## MINERALS PROGRAM INSPECTION REPORT PHONE: (303) 866-3567

MINE NAME:	MINE/PROSPECTING ID#:	MINERAL:	COUNTY:
Diehl Borrow Pit	M-2018-054	Borrow material for construction	Larimer
INSPECTION TYPE:	<b>INSPECTOR(S):</b>	INSP. DATE:	INSP. TIME:
Monitoring	Amy Eschberger, Rob Zuber	February 13, 2020	11:00
OPERATOR:	OPERATOR	TYPE OF OPERATION:	
SEMA Construction, Inc.	REPRESENTATIVE:	111 - Construction by Goverment Agency	
	Tyson Geist

Encls: Approved Mining Plan Map

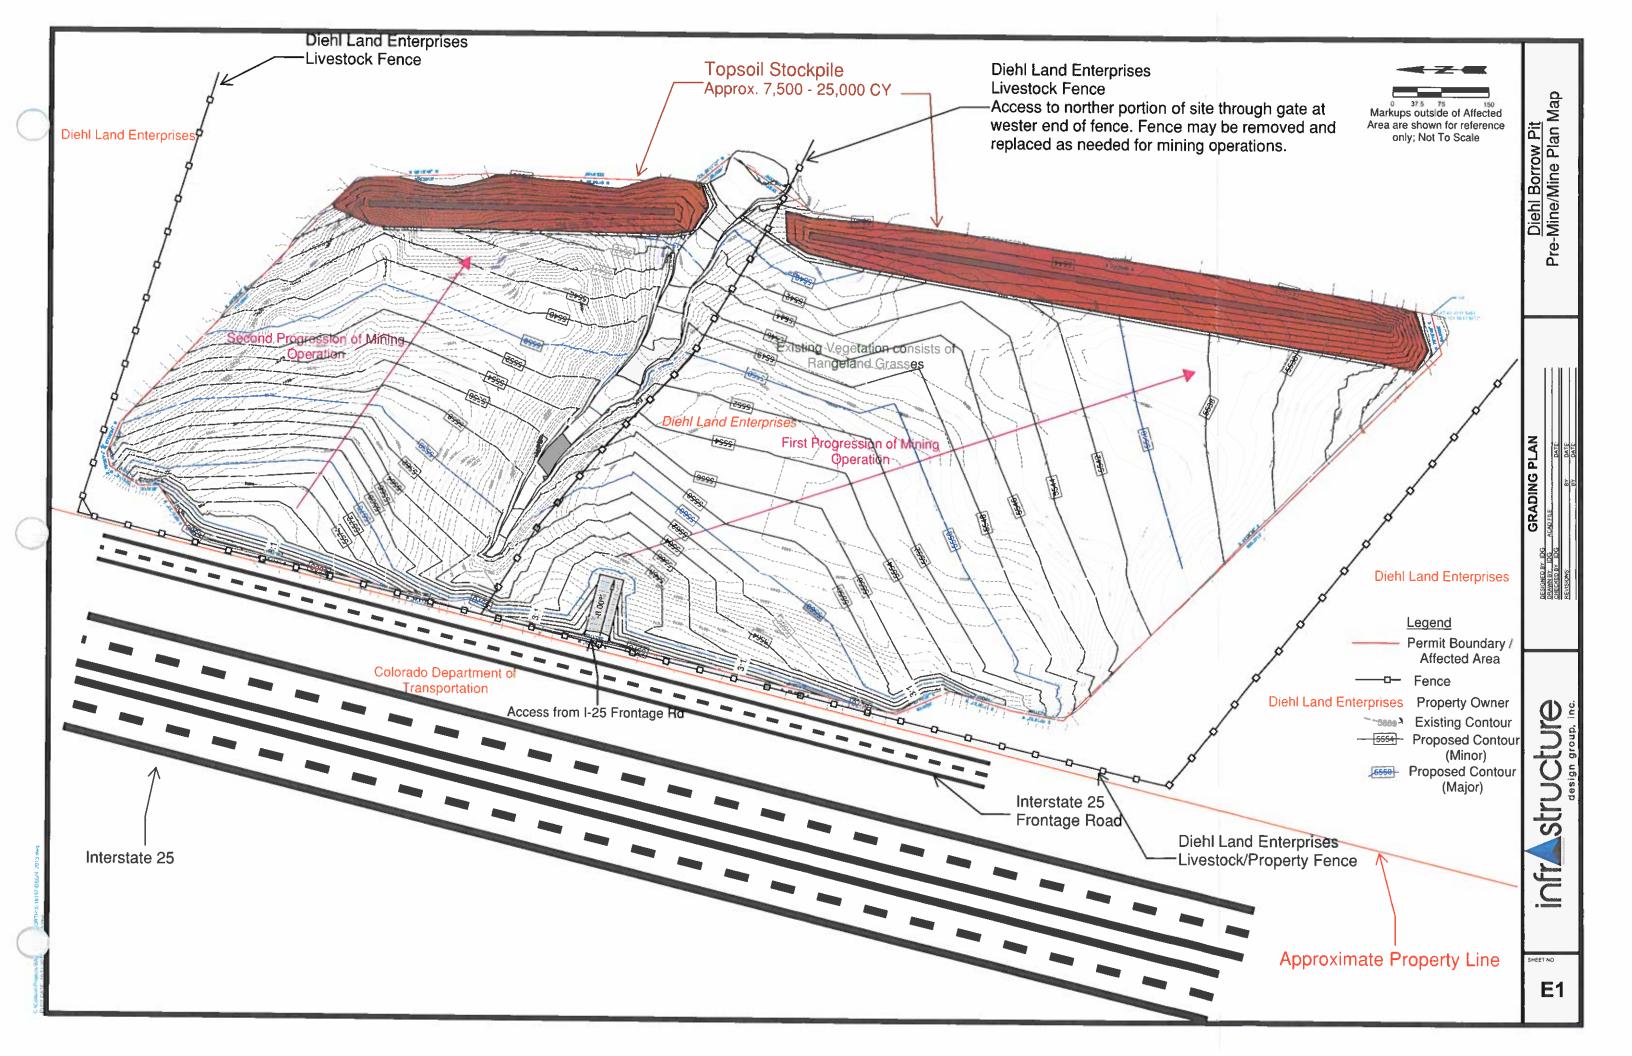
**PROBLEM:** The current mining plan map needs to be updated pursuant to Rules 6.4.3 and 6.4.4. The operator must provide sufficient information to describe or identify how the operator intends to conduct the operation. Specifically, the operator has created a new access road to the site which is not portrayed on the approved mining plan map.

During the inspection, the Division observed a new gated access road has been constructed off the I-25 frontage road to enter the northern half of the permit area. This additional mine entrance is not portrayed on the approved

mining plan map. Therefore, a problem is cited in this report (see pages 1 and 2) pursuant to Rules 6.4.3 and 6.4.4, requiring the operator to submit a Technical Revision (see enclosed form) to update the mining plan map to portray the new access road constructed at the site. This new access road is also not portrayed on the current reclamation plan map. Therefore, a separate problem is cited in this report (see page 2) pursuant to Rules 6.4.5 and 6.4.6, requiring the operator to submit, in the same Technical Revision, an updated reclamation plan map that portrays reclamation of the new road. If the operator proposes to leave any roads for reclamation, this must be reflected on the reclamation plan map. Additionally, the Division would need to receive a notarized letter from the landowner agreeing to leave the road(s) for reclamation.

**CORRECTIVE ACTIONS:** By the corrective action date, the operator shall submit a Technical Revision, with the required \$216 fee, to update the current approved mining plan map to reflect existing and proposed activities at the site, particularly to portray the new access road constructed at the site.

Approved Reclamation Plan Map

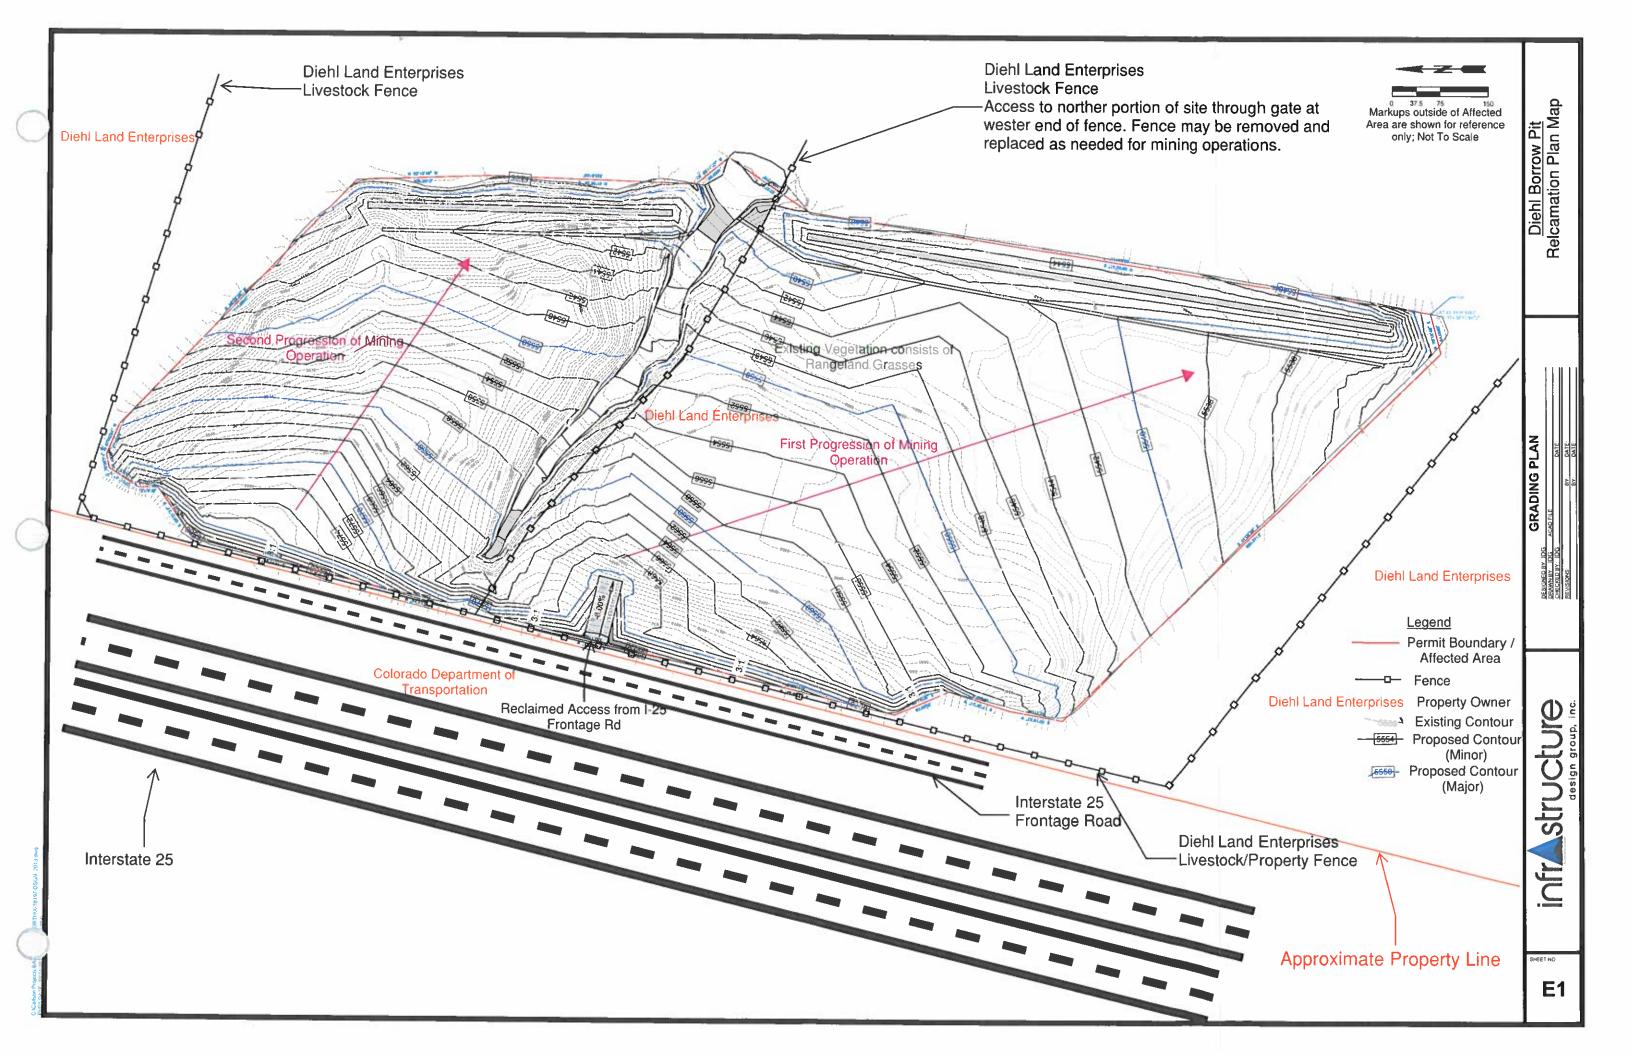
**PROBLEM:** The current reclamation plan map needs to be updated pursuant to Rules 6.4.5 and 6.4.6. The operator must describe how reclamation will be achieved on all affected land. Specifically, the operator has constructed a new access road to the site which is not portrayed on the approved reclamation plan map.

**CORRECTIVE ACTIONS:** By the corrective action date, the operator shall submit a Technical Revision, with the required \$216 fee (can be same revision submitted for problem cited above), to update the approved reclamation plan map to reflect existing and proposed activities at the site, particularly to portray reclamation of the new access road. If the operator proposes to leave any roads for reclamation, this must be reflected on the reclamation plan map. Additionally, the Division would need to receive a notarized letter from the landowner agreeing to leave the road(s) for reclamation.
